Ref: 301015-02022

12th December 2013

**66A DONCASTER AVENUE, RANDWICK
FLOOD CONSTRAINTS ASSOCIATED WITH POTENTIAL USE OF SITE AS A LIGHT RAIL
STABLING FACILITY**

Figure 1 Options for Light Rail Stabling Facility Location

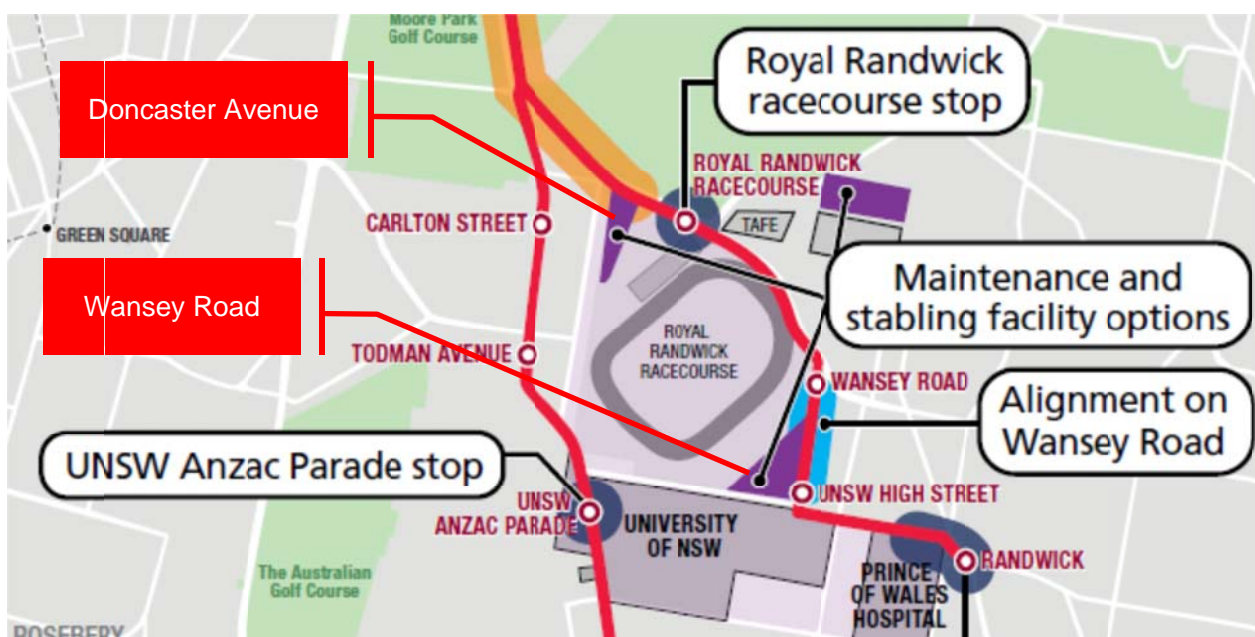
A number of opportunities and constraints were identified for both sites. However the “key differentiator” which led to the selection of the Doncaster Avenue site as the preferred option was that the Wansey Road site is currently occupied by a number of horse stables which would require relocation. This was determined to incur additional costs and would require a greater extent of property acquisition relative to the Doncaster Avenue site.

No mention is made in the site selection summary (*Section 4.5.1 of the EIS*) of any of the following:

- flooding issues experienced at the Doncaster Avenue site
- potential impacts existing flood behaviour would have on operations at the site
- costs associated with works required to improve the Doncaster Avenue site to provide acceptable flood risk for operations at the site
- costs associated with upgrading both the local and downstream trunk drainage systems to ensure no negative impact on flood behaviour to surrounding developments.

It is not known whether the above issues were considered as part of the site selection process at all or were thought to be insignificant.

It appears that the Wansey Road site is predominantly, if not completely, outside the flood extents for all events up to and including the Probable Maximum Flood (PMF). Hence, the development of the Wansey Road site as a stabling facility would not require expenditure to address flooding or flood management issues.

Figure 2 Conceptual Layout for Doncaster Avenue Light Rail Stabling Facility

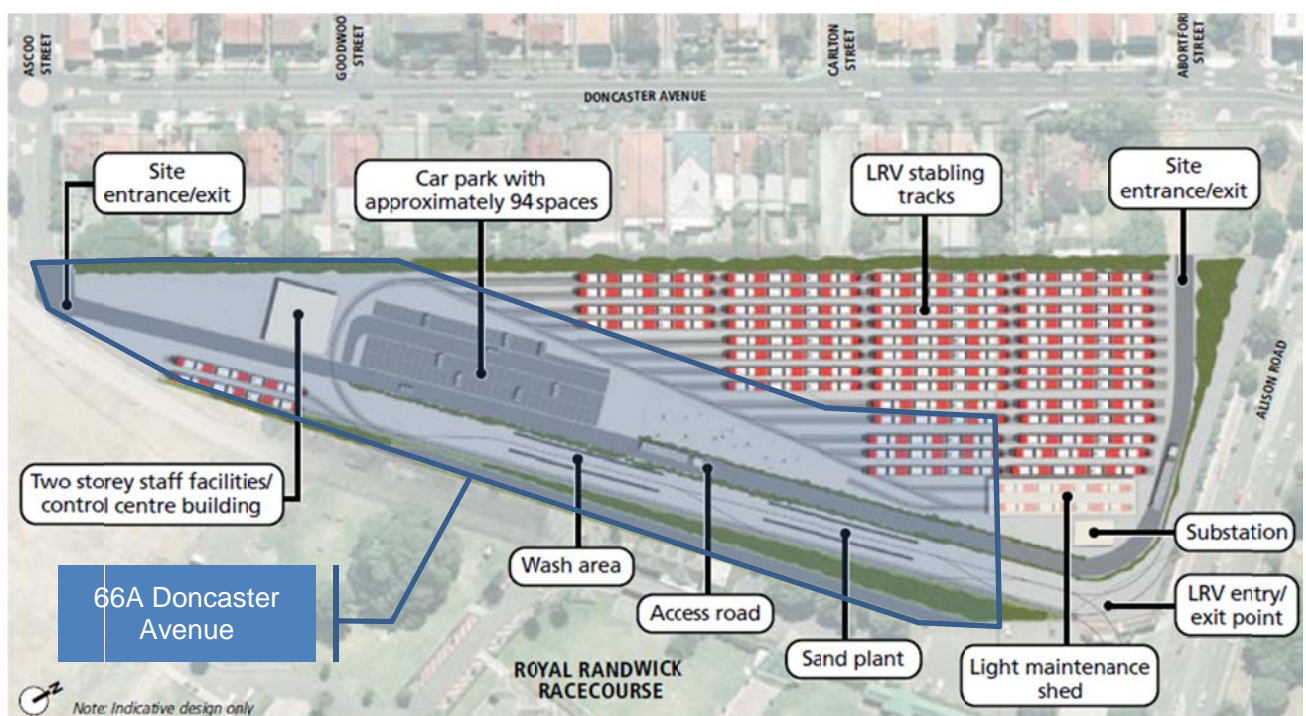
Design details of the proposed stabling facility at Doncaster Avenue are limited due to the project being in the early planning stages. The concept plan shown in **Figure 2** provides the greatest level of design detail that has been found to be available.

The boundary of the property owned by Anson City Developments 1 Pty Ltd and referred to as 66A Doncaster Avenue, has been added to this figure. This shows that the light rail facility extends beyond the boundary of this site to include additional lands to the north and to the west.

No information has been located which provides proposed finished surface levels for the stabling facility. However, it is noted in the EIS (*Section 10.2.2*) that the proposed stabling facility will likely be raised above existing levels such that it is “*closer to the existing road levels in Alison Road*”.

However, it is noted in **Figure 2** that a substation and light maintenance shed are proposed near the northern boundary, which is currently a flood affected area. The substation would likely require a high level of flood protection and need to be located above the 100 year ARI flood level, therefore requiring significant filling at this location. The light maintenance shed could also be an obstruction to overland flows which could alter local flood behaviour. The unmitigated impacts of these items would likely be increased flood levels on surrounding properties.

FIGURE 7
DRAINAGE NETWORK LAYOUT

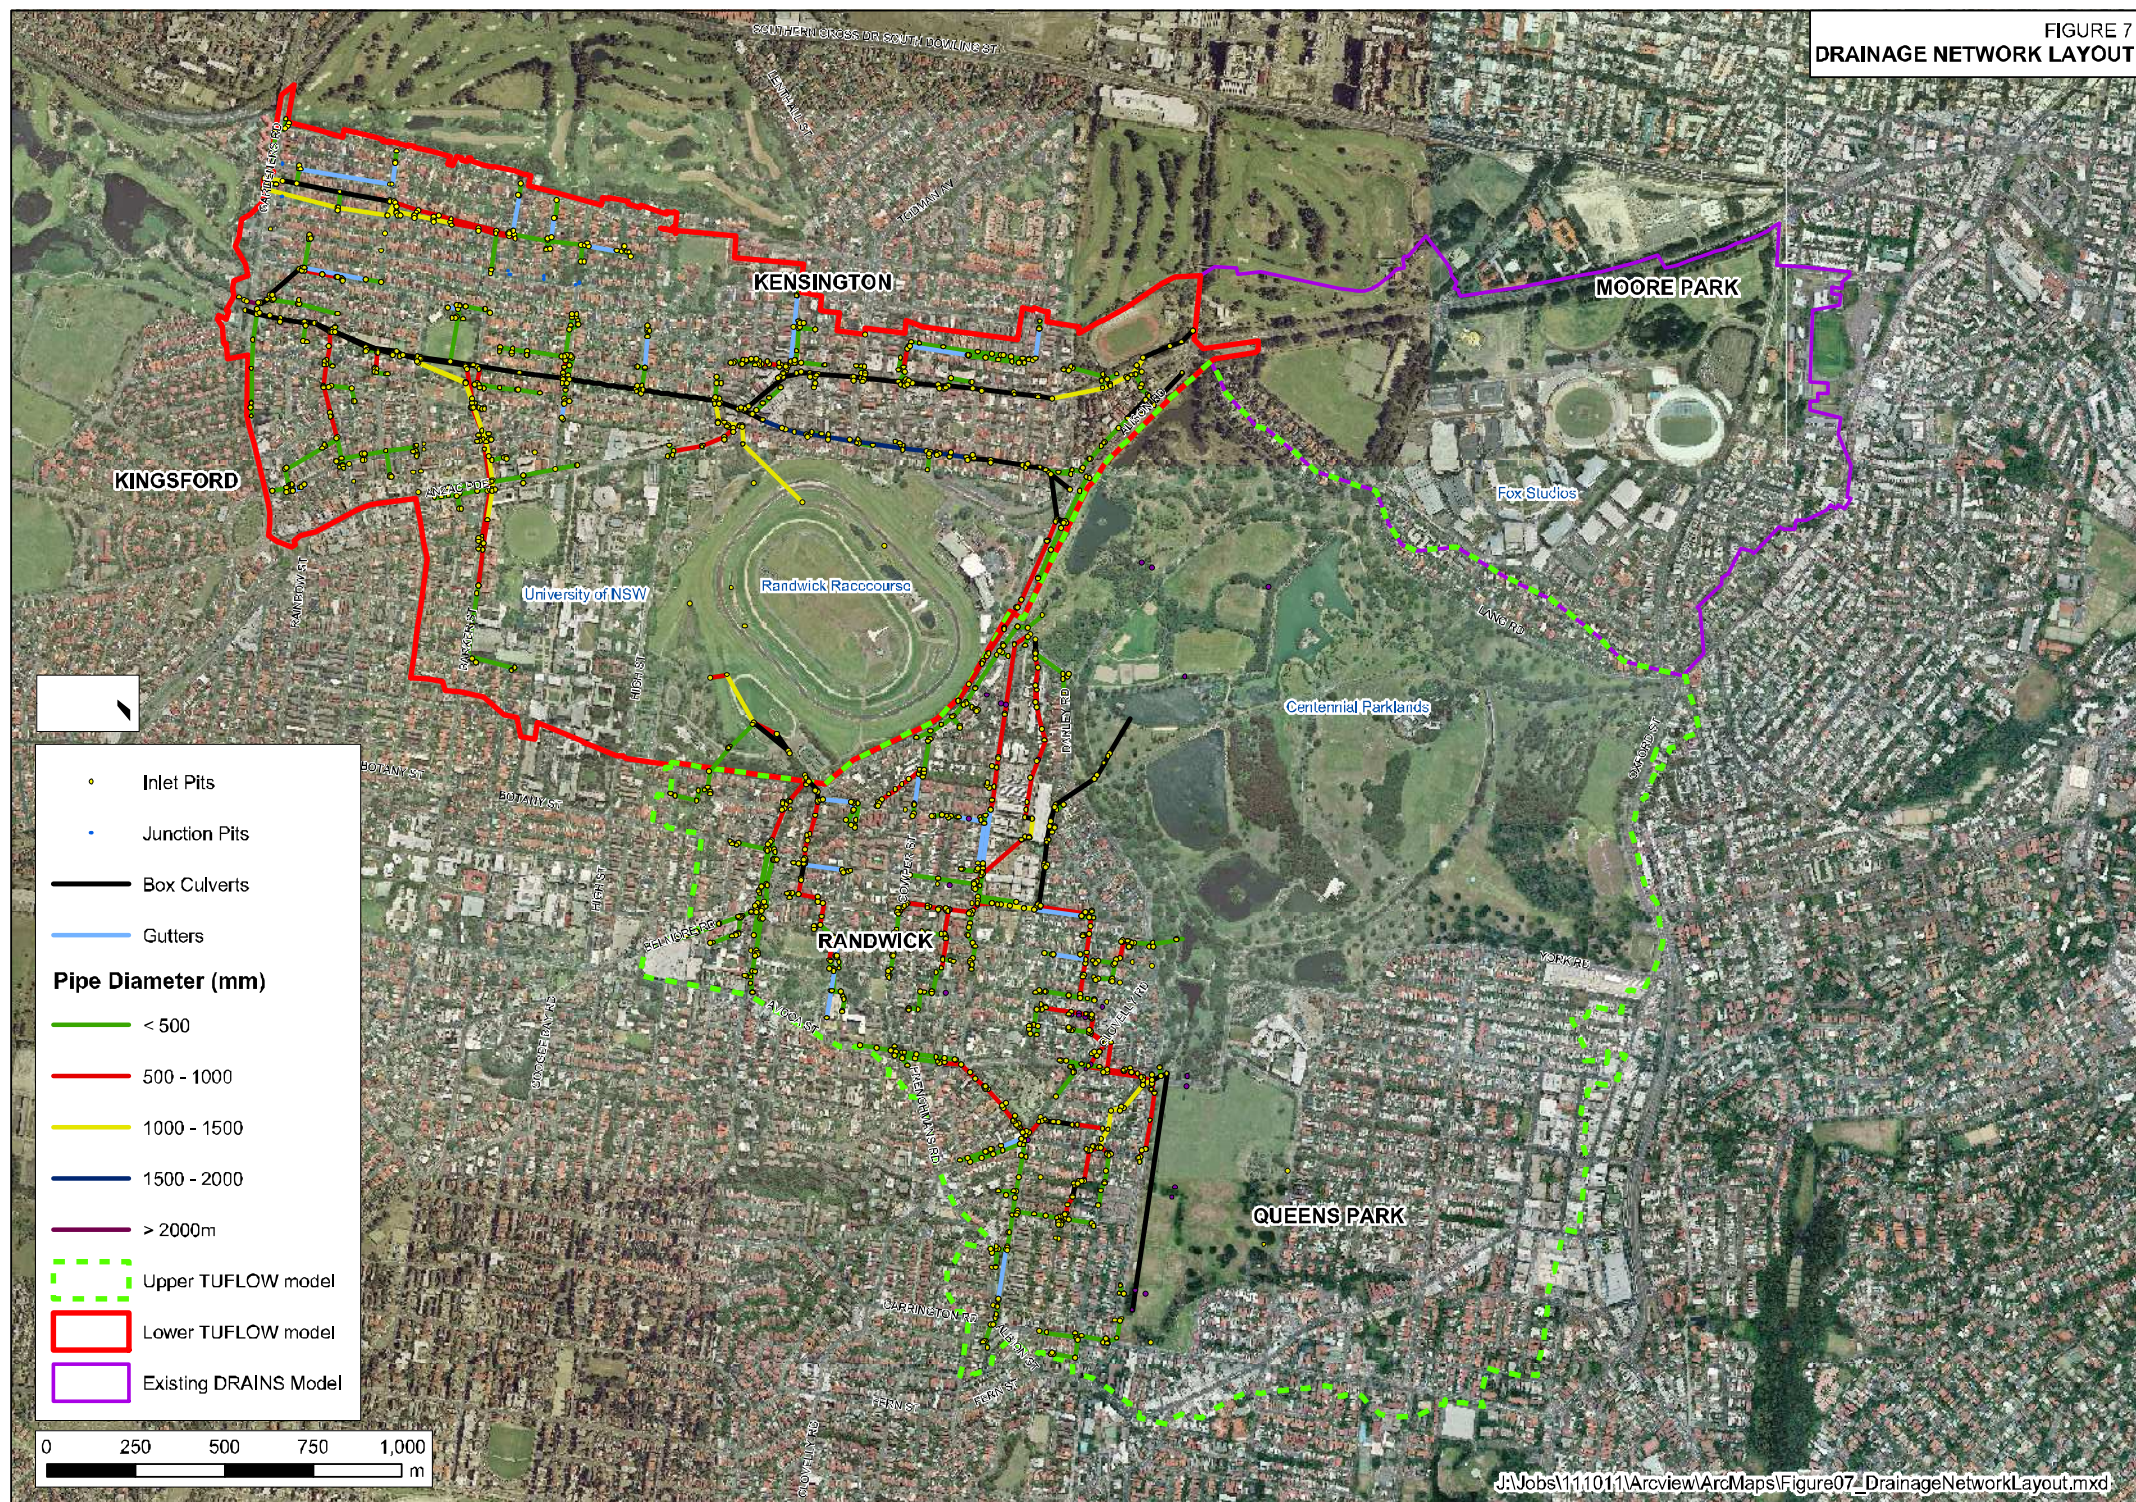
The trunk drainage system downstream of the site, as shown in the KCPFS and included in **Attachment B**, consists of approximately 2.5 km of box culverts and large diameter pipes (1500 – 2000 mm diameter) that ultimately discharge downstream of Gardeners Road, adjacent to Eastlake Golf Club. While the KCPFS does not comment on the capacity of this system, it appears to be almost entirely under capacity as flooding can be found along the entire length of the system for the 5 year ARI event. Given the size of the existing infrastructure and the length of the system to the discharge location, upgrading this system would be **logistically very difficult and extremely expensive**. Utilising surcharge pits could limit the extent of the required upgrades, however finding a suitable site where flows could be safely surcharged would be very difficult.
